STAFF REPORT
KETCHUM PLANNING AND ZONING COMMISSION
REGULAR MEETING ON FEBRUARY 28, 2023

- PROJECT: McGavick Residence
- FILE NUMBER: P22-048A
- APPLICATION: Mountain Overlay Design Review (Final)
- PROPERTY OWNER: The Dirty Foot Gang LLC
- REPRESENTATIVE: Jim McLaughlin, McLaughlin and Associates (Architect)

- LOCATION: 307 Garnet Street (ESMERALDA SOUTH SUBD LOT 2 BLK 1)
- ZONING: Limited Residential (LR)
- OVERLAY: Mountain Overlay
- REVIEWER: Morgan Landers, AICP - Senior Planner

GRADING AND DRAINAGE PLAN

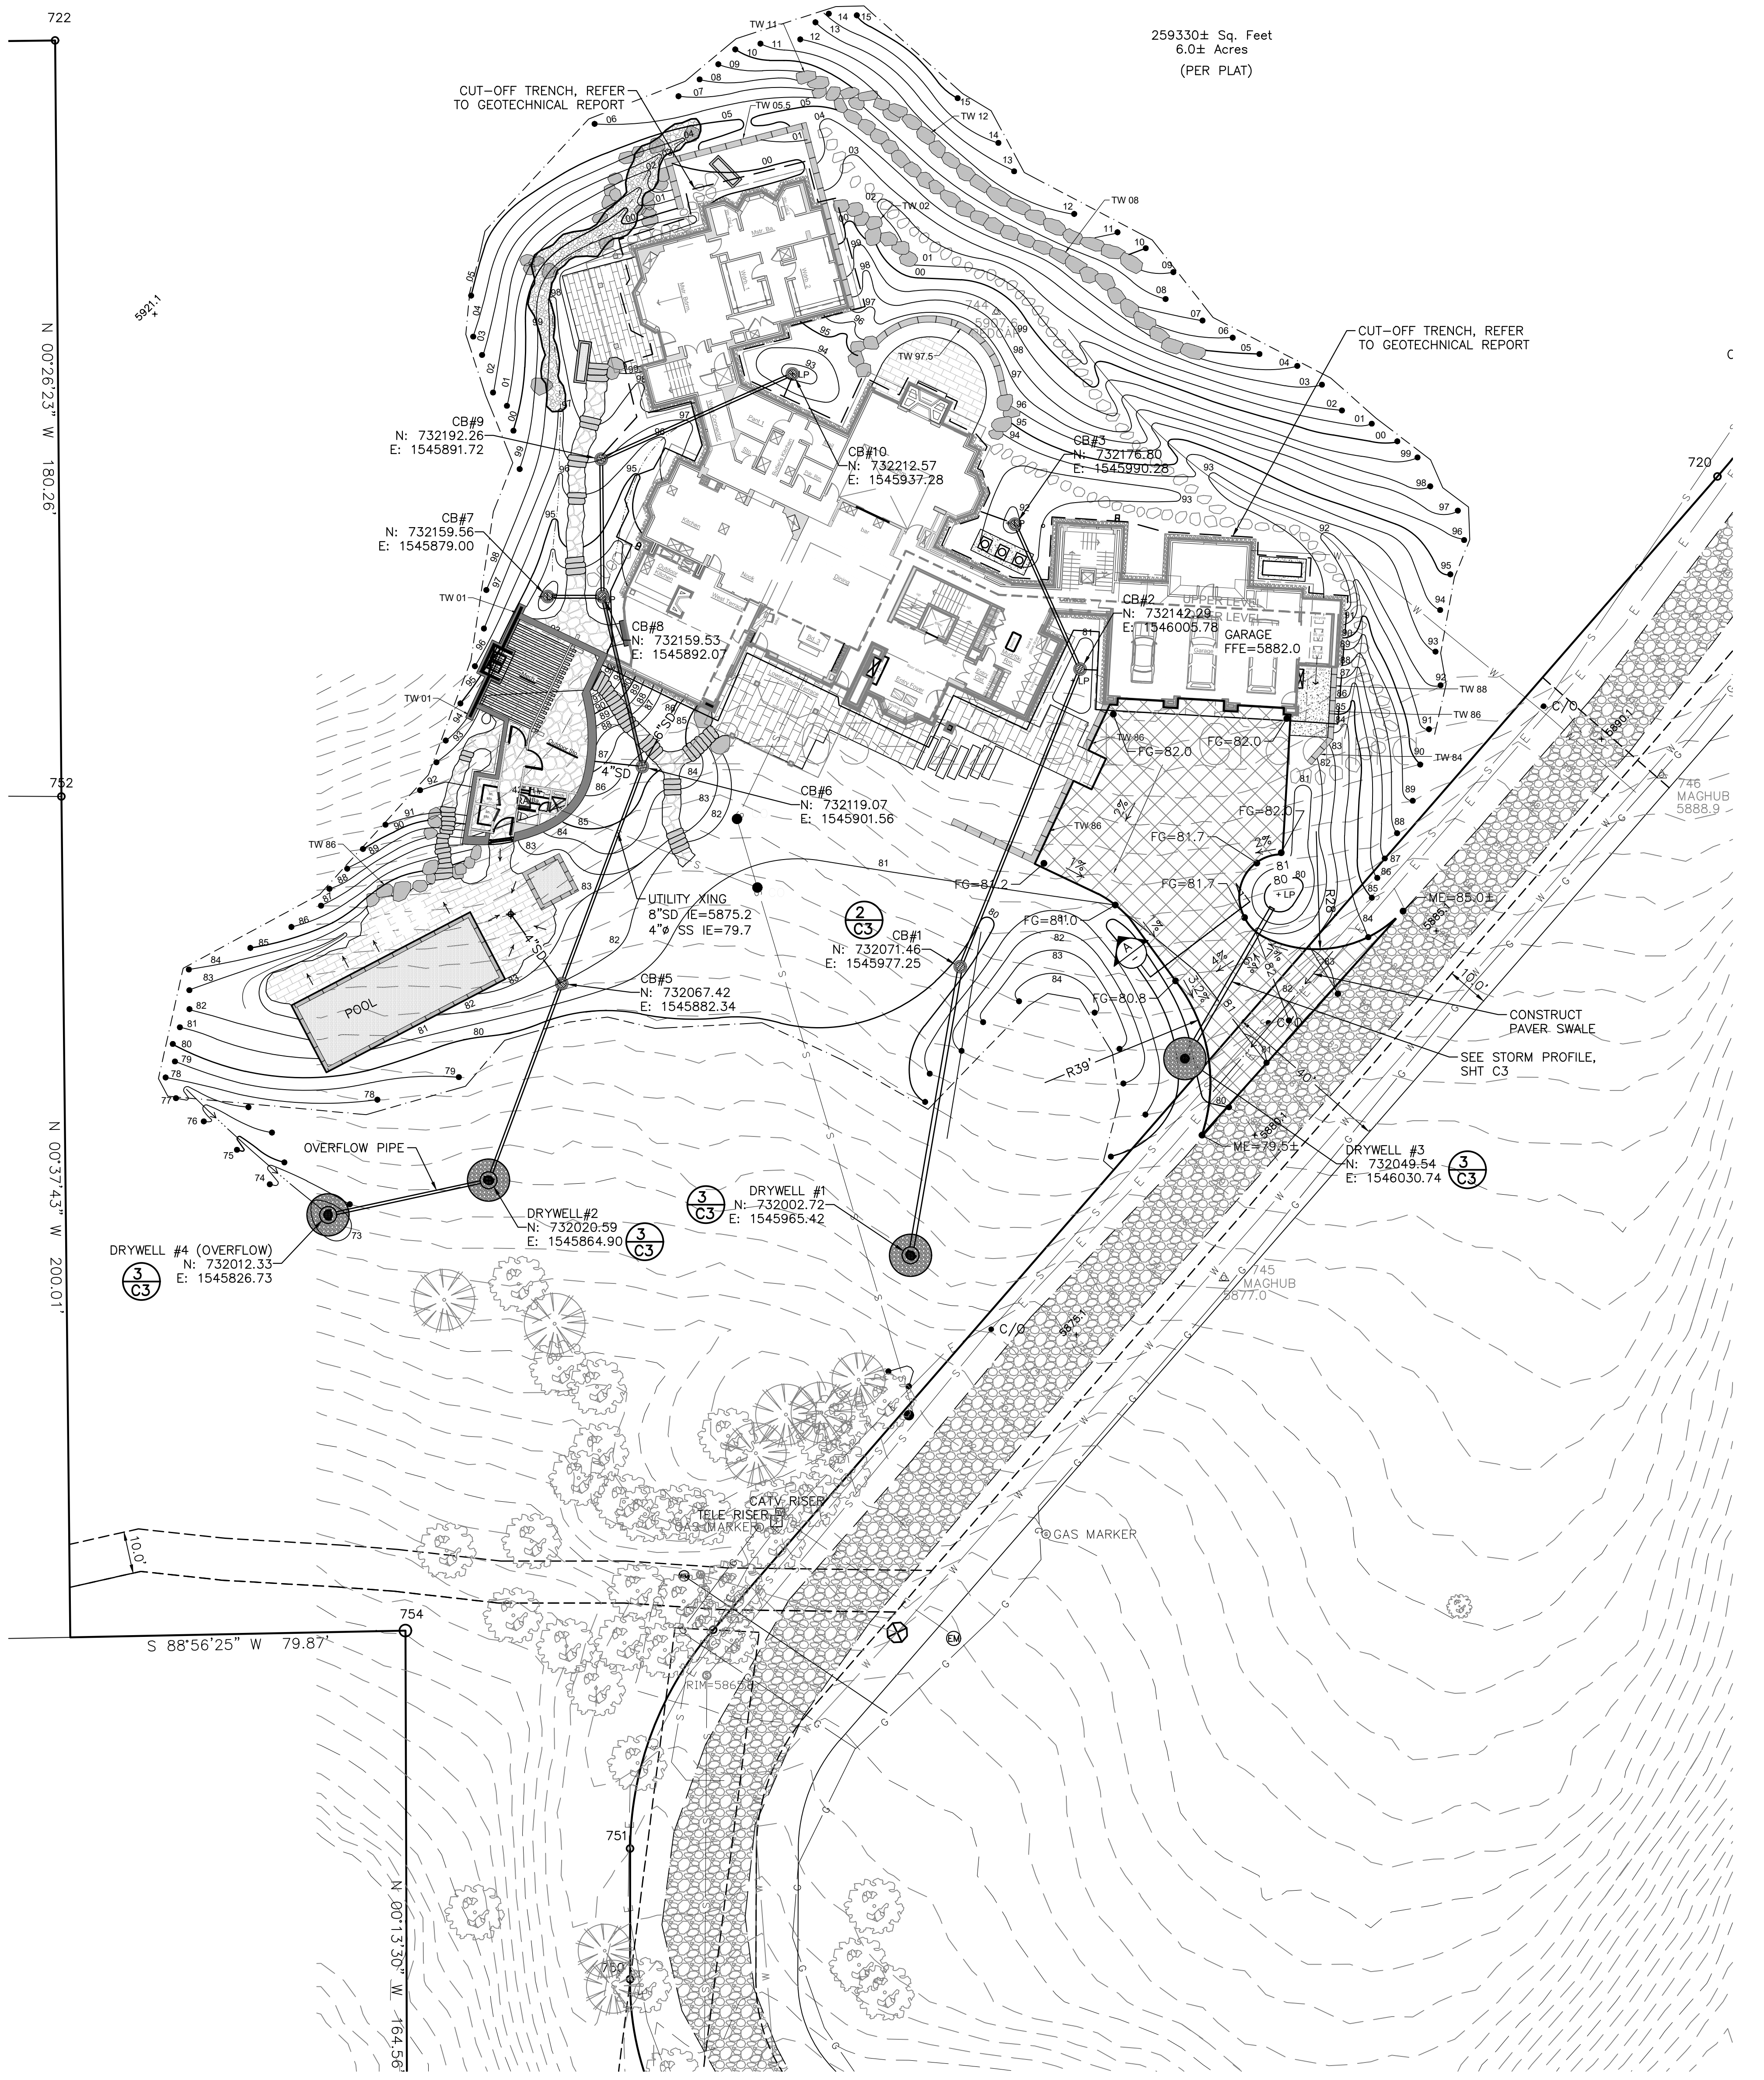
At the preapplication review of the project, staff raised concerns about the drainage proposed and associated disturbance necessary to accommodate the drainage along the existing private driveway. KMC §17.96.060.C1 and 17.124.170.A.1, requires that all stormwater must be retained on site. The initial project plans included proposed drainage that funneled all stormwater along a newly created drainage swale along the private drive, south and off the property. The applicant has worked with the City Engineer to revise the grading and drainage plan to manage the stormwater on-site as required. Attachment XX includes an analysis conducted by the applicant team that demonstrates how the stormwater on-site will be managed adequately. Additionally, the revised grading and drainage plan reduces the amount of grading and disturbance outside the building envelope as required by plat note 4. Staff believes the drainage concerns raised during the preapplication meeting have been resolved.

existing drainage conditions from the undeveloped site and developed conditions with the proposed project. The applicant revised the drainage plan to effectively manage any additional drainage needs resulting from development of the property. The city engineer concluded that the proposed drainage plan shows a decrease in stormwater flow from existing conditions. Therefore all stormwater resulting from the development of the site will be retained on site.
<input checked="" type="checkbox"/>	<input type="checkbox"/>	<input type="checkbox"/>	17.96.060(C)(2)	Drainage improvements constructed shall be equal to the length of the subject property lines adjacent to any public street or private street.
			<i>Finding</i>	As shown on Sheet C1 and drainage improvements are placed in a way that manages all stormwater from the development of the site. The existing private driveway that serves all three lots contains drainage swales on either side that run the length of the driveway and manage stormwater from the driveway specifically.
